SERVICE BULLETIN**N° 189-160****DATE:** September 6, 2017**REV. :** A - February 16, 2022

TITLE**ATA 34 – TCAS II UPGRADE TO MODEL RC TTR-4100****REVISION LOG**

Figure 1

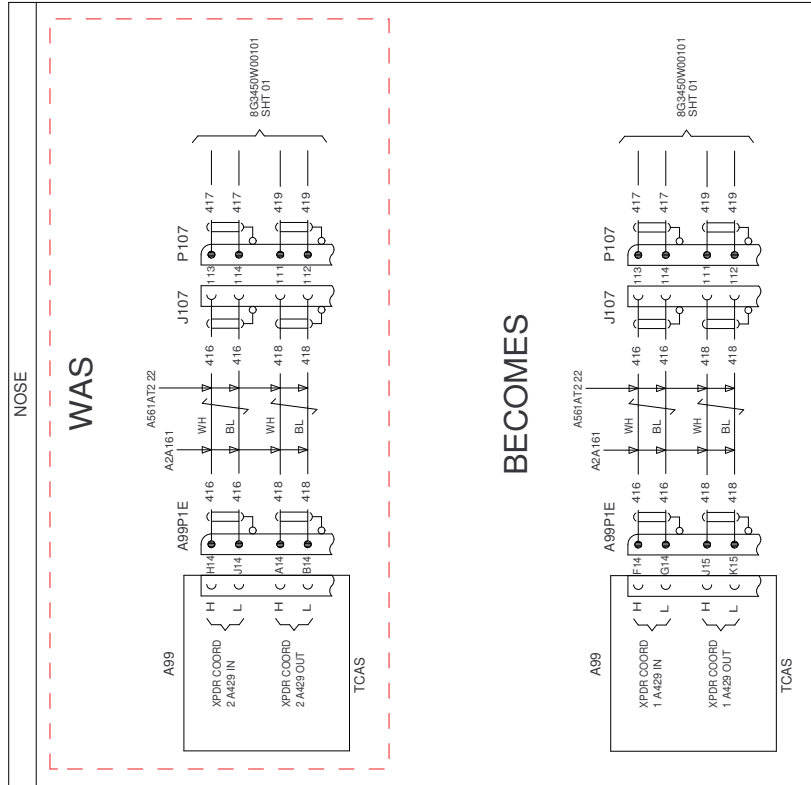
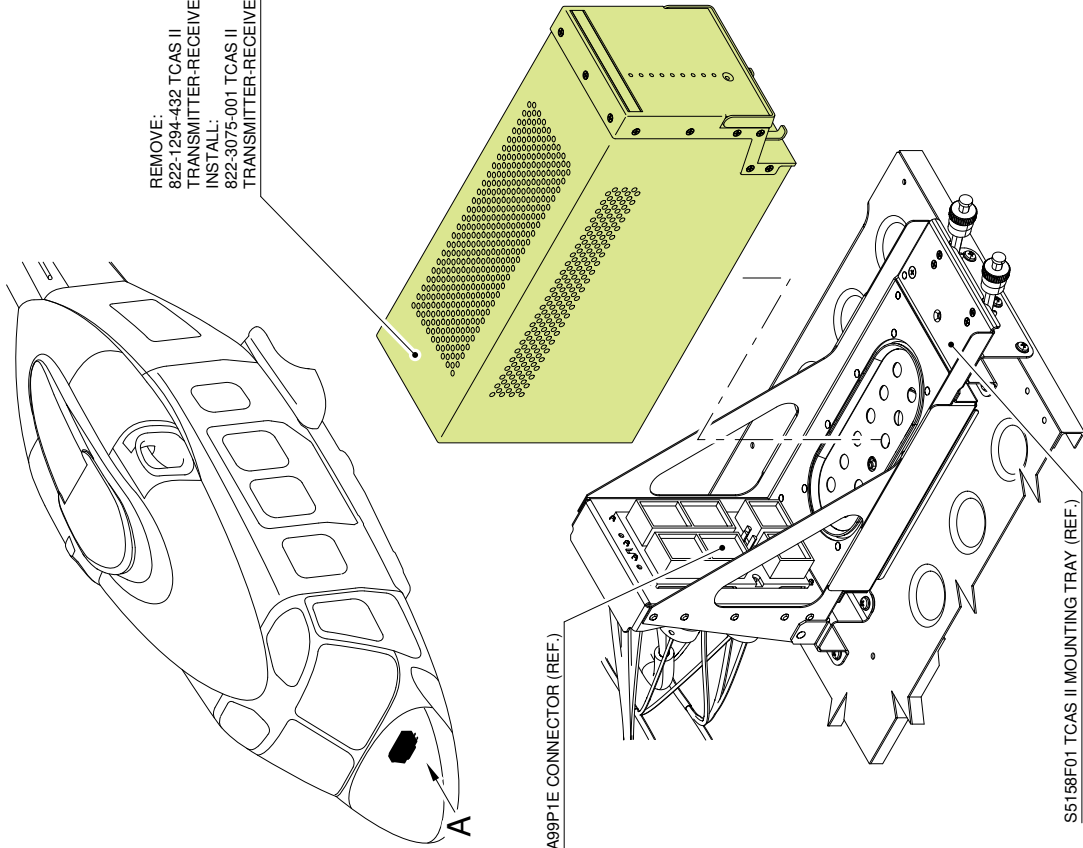
1 BEFORE INSTALL THE NEW TCAS II TRANSCIEVER, MODIFY THE ELECTRICAL CONNECTION OF A99P1E CONNECTOR AS SHOWN IN DETAIL B.

1 REMOVE:
822-1294-432 TCAS II TRANSMITTER-RECEIVER (REF.)
INSTALL:
822-3075-001 TCAS II TRANSMITTER-RECEIVER

4. With reference to Figure 1 wiring diagram BECOMES view, perform the new electrical connections on connector A99P1E.
 5. With reference to Figure 1 and in accordance with AMP DM 89-A-34-44-01-00A-720A-A install TCAS II transmitter-receiver P/N 822-3075-001.
